Crown Exclusive Wears Ltd. (Extended Building)

2nd December 2020

1. Factory Storage Building (G+5)

Observations

Design report

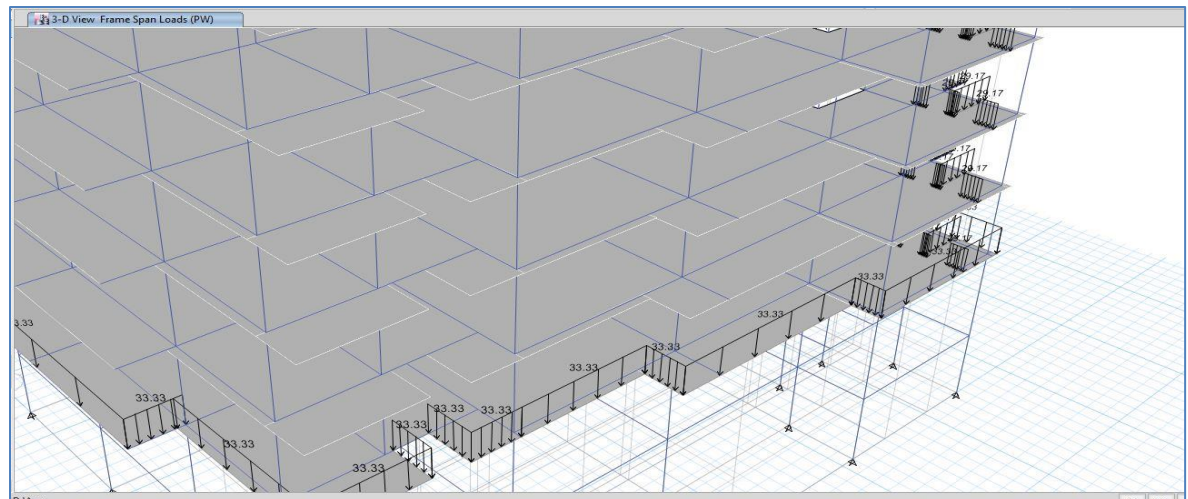
**Prepared design report not compliant with
BNBC**

Serviceability checks as per BNBC were not provided in the design report. Also, brick wall load was not assigned in FEM model. Building engineer is required to check the serviceability issues as per BNBC and incorporate proper loading assignment in the design report.

As per BNBC every building or structure designed shall have its design documents prepared in accordance with the provision of Section 1.9.1. The design document shall include a design report, and a set of structural drawings, which shall be prepared in compliance with section 1.9.1.1 and section 1.9.1.2 as per BNBC.

Connection bridge

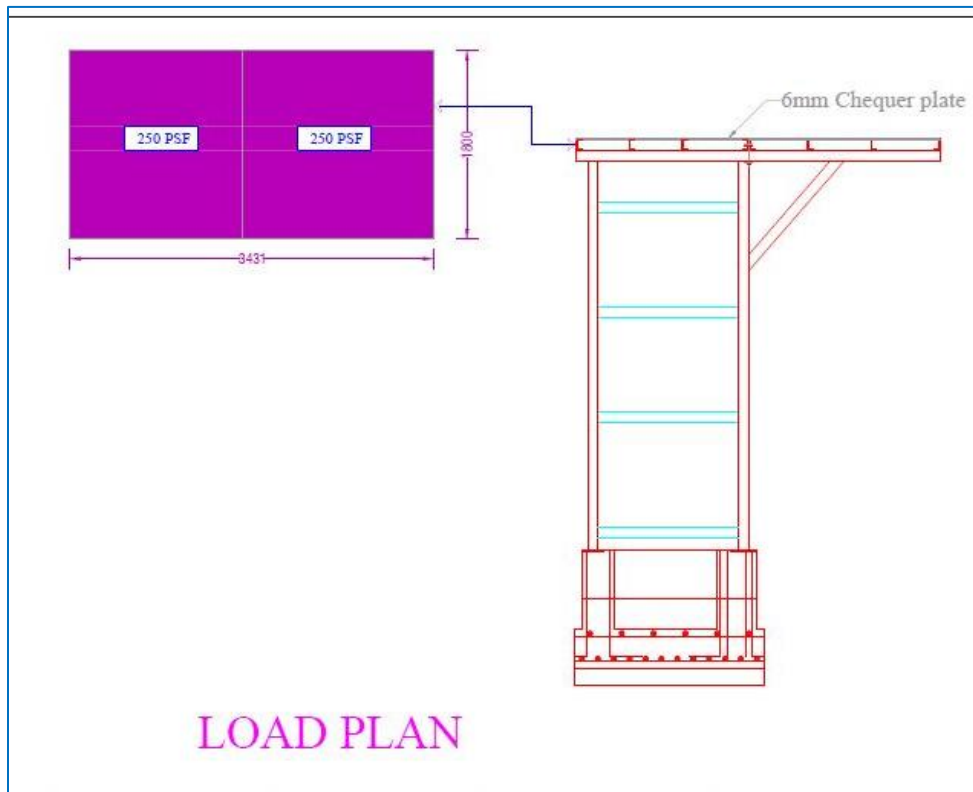
Lack of information in as-built drawing of connection bridge

Connection details are not provided in as-built drawing of connection bridge. Building engineer is required to prepare proper as-built drawings.
